25_02583_FUL - Parish Council - Objection

Application Reference: 25_02583_FUL

Proposal: Wetland enhancement works upstream of Sherborne Broadwater to reconnect river with floodplain, manage silt, preserve open water, improve biodiversity, and mitigate flood risk.

Appendix 2 – Hydrological Review Report

Figure 2: Citizen Science investigation of water quality - November 2023

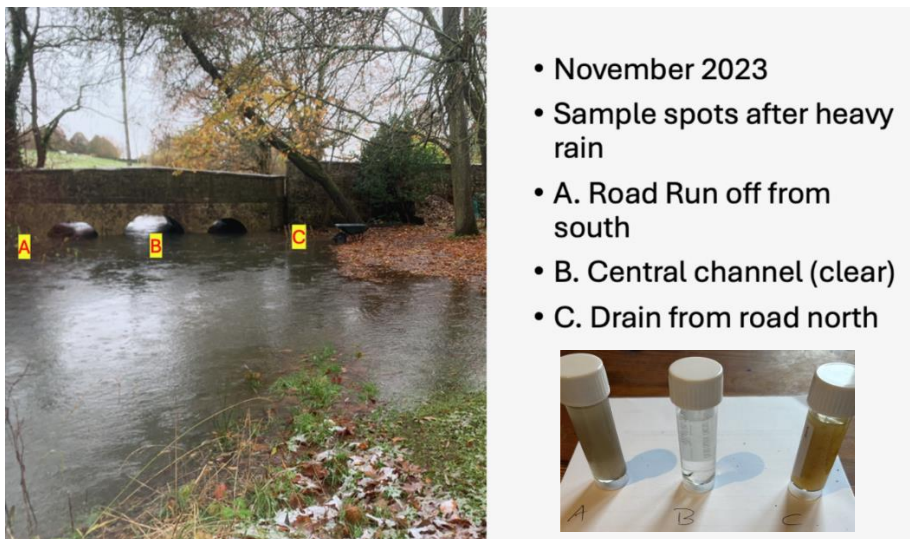
- *Figure 2* and shows how the main flow in the Brook is clear (Sample B) whilst the inflow from the highway drains to both banks is turbid (Samples A & C) during November 2023. The same effect was also observed in September 2024 (*Figure 3*).
- These observations have led the local residents in conjunction with the Trust to install silt traps and to maintain road grips as direct ways of reducing sediment runoff to the Brook.
- Anecdotally, these measures appear to have been very effective in reducing the amount of direct road run-off into the Brook. However, these measures will require regular maintenance by the community and the Trust. Proposals for an enhanced community scheme involving the construction of some shallow swales and a few small interceptor

Figure 4: The ditch to the south of the Brook

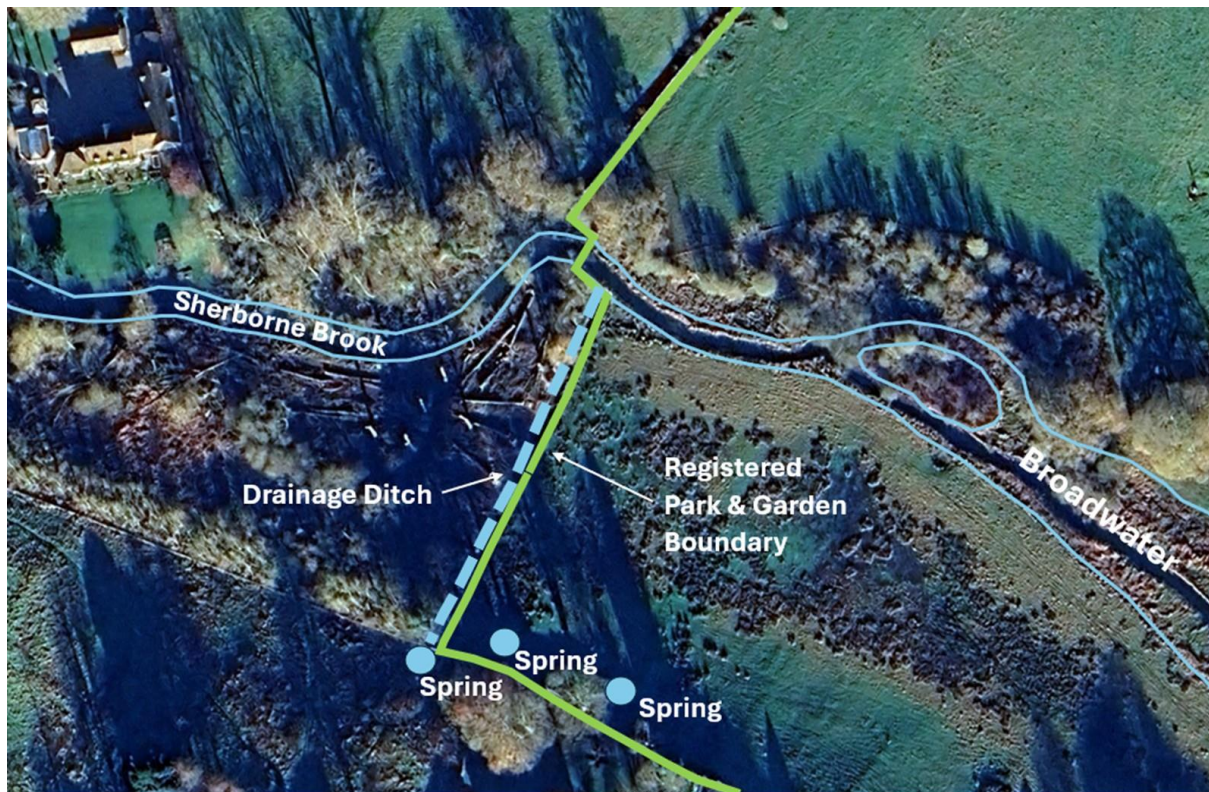
The ditch conveys water from a spring on the south side of the valley towards the Brook (

- *Figure 4* and 5). It flows continuously, with enhanced flows in winter and spring. Lack of maintenance in recent years has led to colonisation by aquatic and marginal vegetation. This reduction in conveyance has led to the ditch spilling onto adjacent woodland/meadow area which is now seasonally wet; previously it was dry throughout the year.
- In the scheme, it is proposed that the ditch is infilled. The likely consequences, aside from loss of habitat, would be twofold. Flow from the spring would be directed towards the areas of “floodplain lowering” where they would lead to elevated groundwater levels and marshy conditions. Secondly, the Brook would be deprived of the flow contribution from the spring – a largely “clean” source with low silt concentrations.
- The second impact seems to be contrary to the principles of sustaining open water in Broadwaters.

Figure 6: Location of deposition area

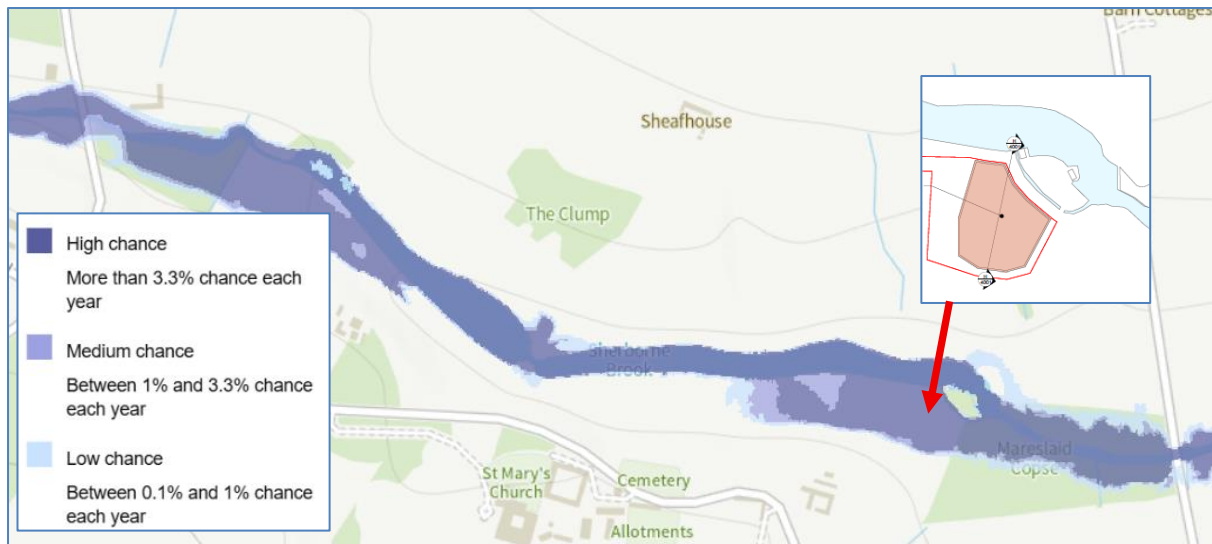
It is proposed that the excess soil from the scheme will be deposited at the location shown in

- *Figure 6* on the downstream bank of the Lower Lake. This is in an area with a “high chance” of flooding, with an annual probability of greater than 1 in 30. This is classed as flood Zone 3b which is “**functional floodplain**”.
- This is contrary to the NPPF and associated guidance where there is no provision for such activity. Even if it was to be an acceptable activity, the Environment Agency would expect to see flood storage compensation on a level for level basis.
- It is remarkable that of all of the available areas within the Estate, that the Applicant has selected such an unsuitable location for deposition and that JBA should have not advised them properly.

Figure 7: Comparison of modelled flood extents

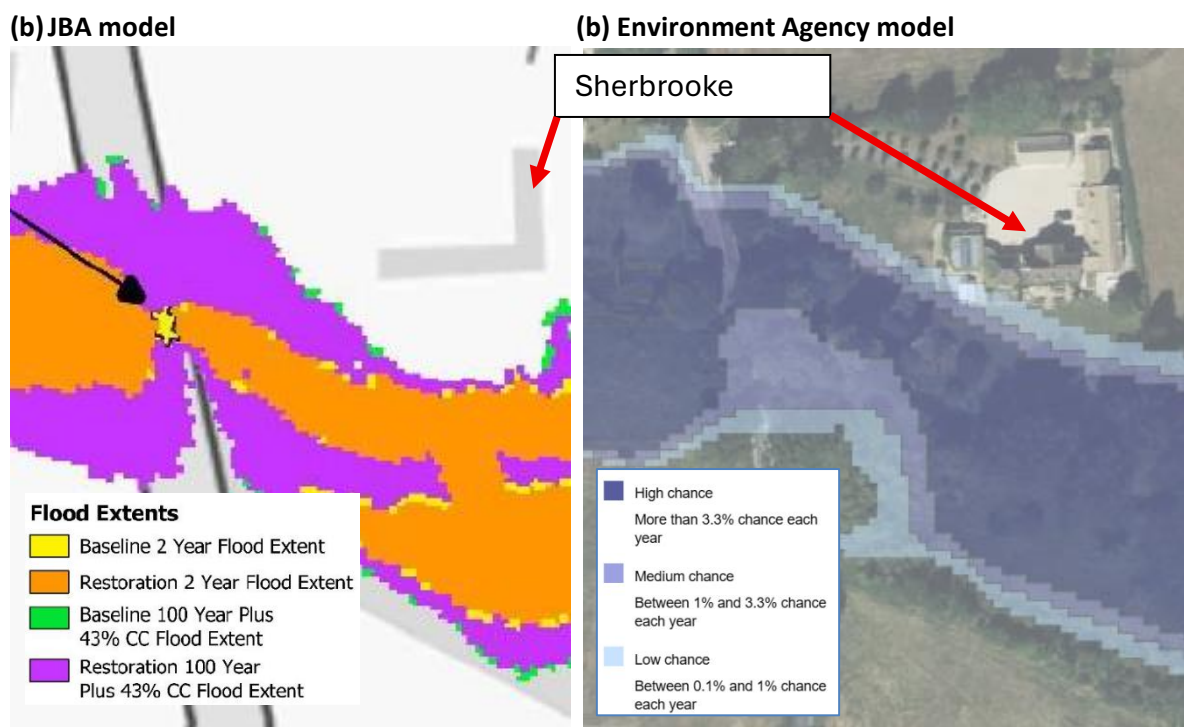
- Whilst calibration of flood models is not usually possible, some attempt should be made to compare baseline results with historic extents (e.g. July 2007) and Environment Agency flood model extents. Neither of these is presented.
- *Figure 7* compares the flood extents from the JBA and the Environment Agency model, as accessed on their website (4th October 2025). There are some notable differences in extent, especially adjacent to the principal flood receptor of Sherbrooke House.

The JBA model results in

- Figure 7a show that post restoration flood extents (in orange and blue) are slightly smaller than the baseline conditions (in yellow and green) near Sherbrooke House – this for the 1 in 2 and 1 in 100 with 43% CC.
- This suggests that the proposed scheme will not lead to an increase in water levels. The increases in levels due to the timber blockages will be more than offset by the lowered sections of bank which will encourage flow onto the floodplain.
